REQUEST FOR INFORMATION	DATE: February 07, 2017	NO.: RFI-441
--------------------------------	--------------------------------	---------------------

Project Name: 15051-Webster University Interdisciplinary Science Building	Project No.: 15051
---	--------------------

Subject: East elevation structural steel window sill

FRAMING SECTION
3/4" = 1'-0"

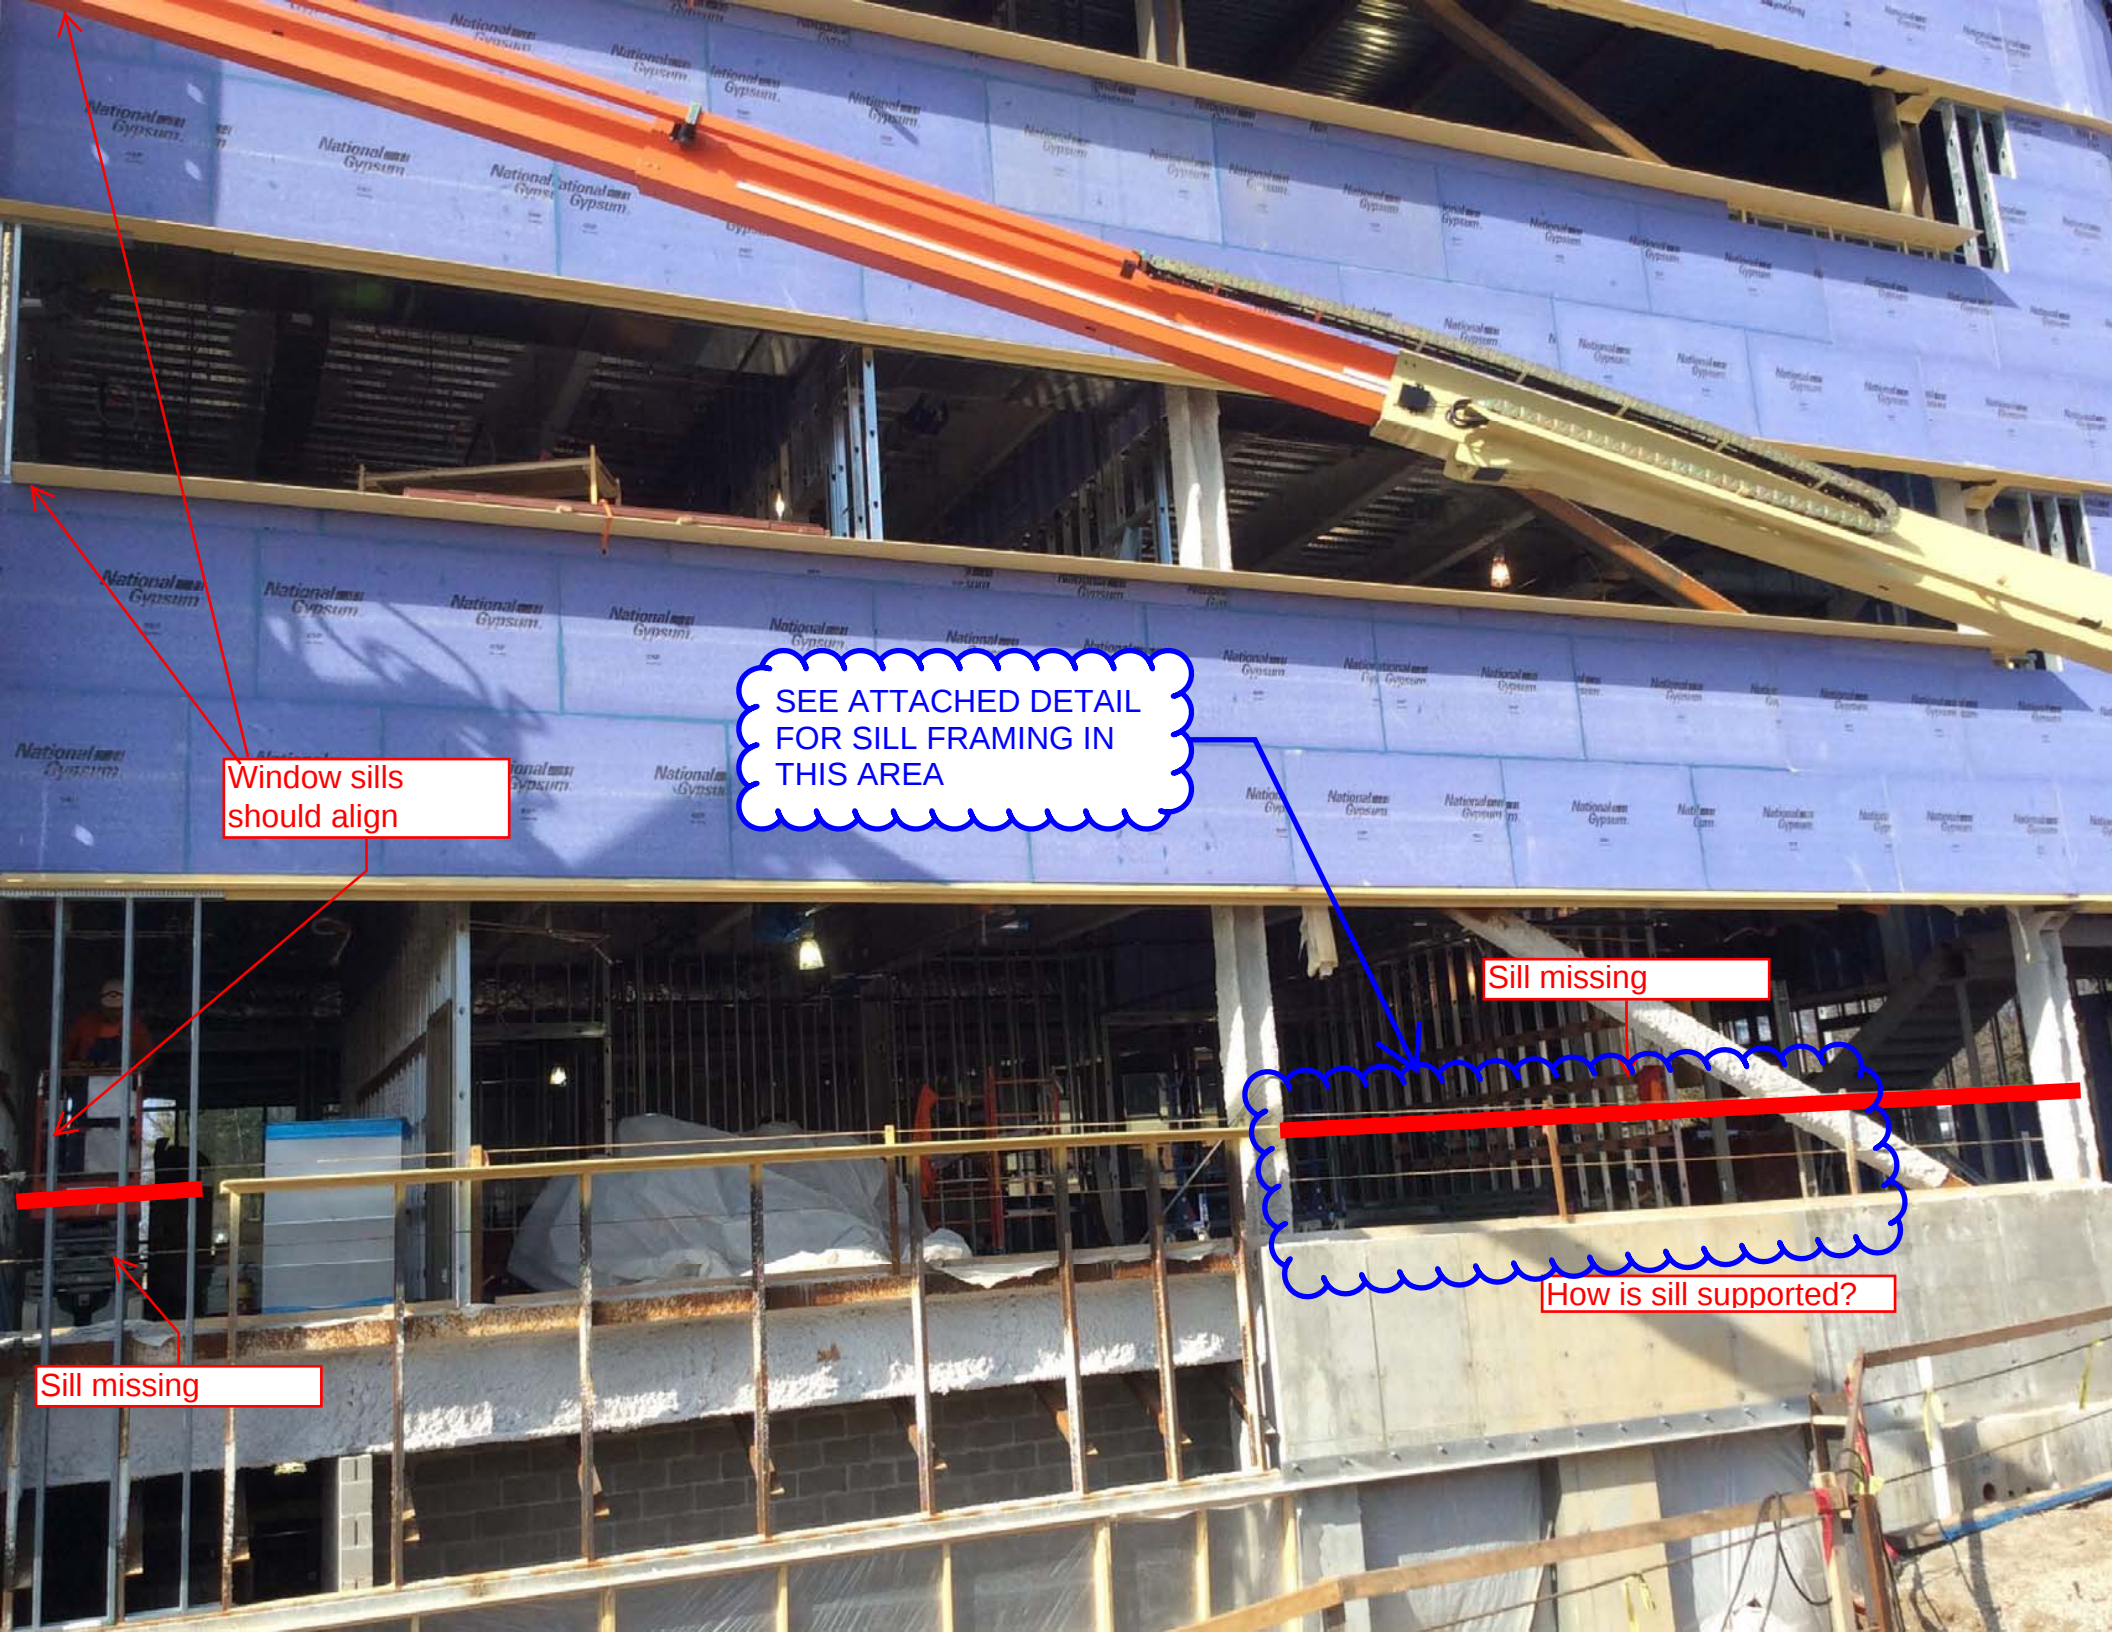
See attached photo. Please advise of what framing and structural steel that should be provided at the missing sill locations on the 2nd floor line. The structural and architectural drawings do not appear to address these areas. Should there be some sort of structural channels supporting a sill that are attached to the top of the concrete wall North of E line? Should the sill continue all the way South to D line instead of transitioning to detail 2/S301 just North of D line?

**SEE ATTACHED DETAIL FOR THE 21' OF
WINDOW SILL FRAMING NORTH OF GRID E**

VIF - 5/8"
ADJUST 1/2" PLATE
SIZE ACCORDINGLY

1/2"x7 1/8"x11" PL TOP &
3/8"x11"x11" PL SIDE
w/4-3/4"Φx6" EMBED
HILTI HIT-HY200 W/1-1/2"
EDGE DISTANCE

SEE 1/S0301 FOR
TYPICAL FRAMING

FIELD WELD FOR
FLEXIBILITY OF ANCHOR
PLACEMENT AROUND
EXISTING REINF - USE PILOT
HOLES, PATCH AS REQ'D
